**Historic District Review Committee
Staff Report
Date of Meeting: September 12, 2011
CAPP2011-0010
Historic District: Waterford
Project Planner: Lauren Murphy**

CAPP 2011-0010 McGuire: Installation of wood porch railing and removal of existing second story balcony. PIN # 303-26-6235. Second Review.

Figure 1: Subject Property, 40171 Main Street, Waterford

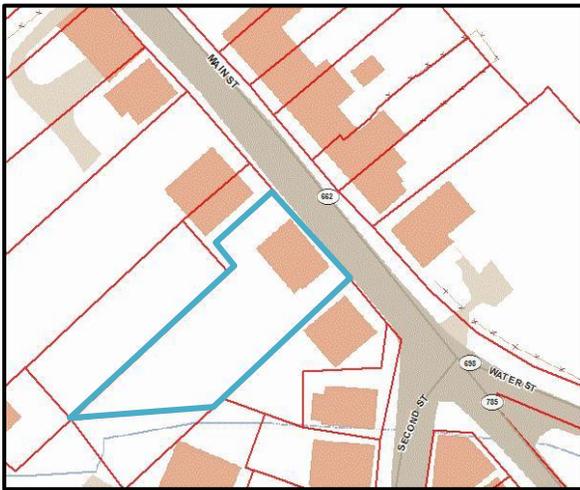
The application proposes a minor modification to the existing second story doorway with the addition of a wood railing. The existing balcony has deteriorated and fallen off the building. The applicants' statement of justification (SOJ) indicates that all remaining fragments of the balcony will be removed and the siding will be repaired or replaced in kind (no CAPP required). The new wood railing will be mounted outside the door jambs and will not significantly alter the form

The Waterford Design Guidelines state that original doors should be retained (Waterford Guidelines, Guidelines for Existing Structures, Doors, page 96, Guideline 1). The installation of the railing will provide necessary security while allowing the historic door to remain operable. **The application meets the Guidelines for doors on existing structures and additions.**

The Guidelines for materials state that wood should be retained as "one of the dominant framing, cladding, and decorative materials for district residences" (Waterford Guidelines, Guidelines for Materials, Wood, page 116, Guideline 4). The use of a wood railing is consistent with other decorative details on the historic building and is more in keeping with the Guidelines than the originally proposed metal grille. Further, the proposed railing is of a simple design, consistent with the style of the building. **Therefore, staff finds the proposed railing is consistent with the Guidelines for materials.**

Staff recommends approval of the revised wooden railing as submitted in the application and approval of the revised chimneys with the condition that they are re-covered in stucco and painted. Please note that two separate motions have been provided below.
